## **2.6 Reactor Auxiliary Systems**

The information in this section of the reference ABWR DCD, including all subsections, tables, and figures is incorporated by reference with the following departure to Figure 2.6.2.

Figure 2.6.2 Fuel Pool Cooling and Cleanup System

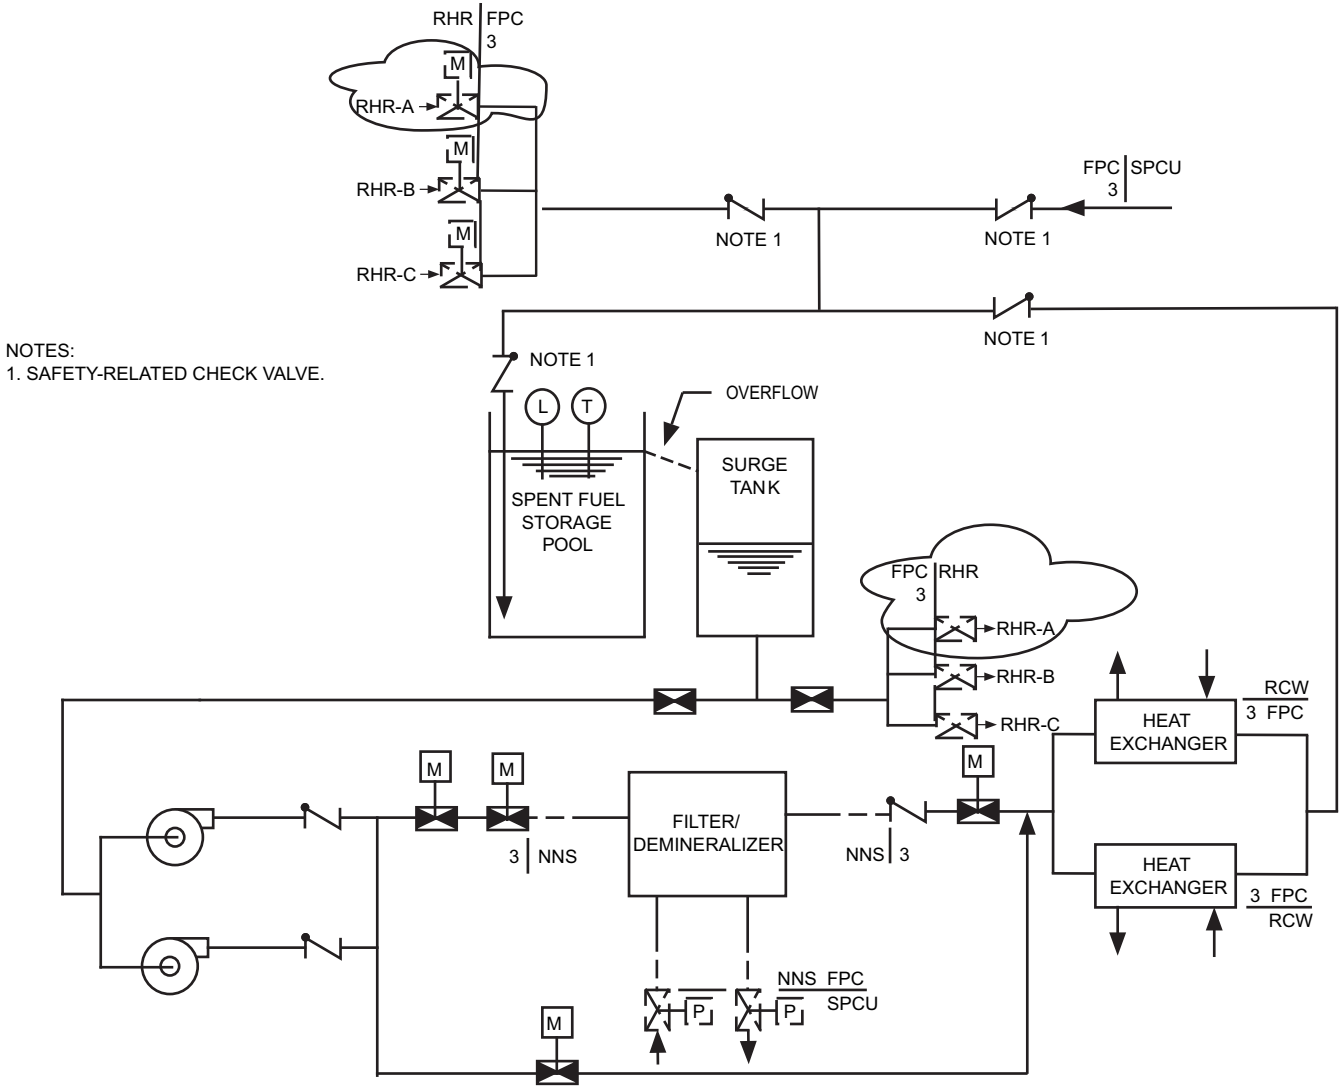
STD DEP T1 2.4-1
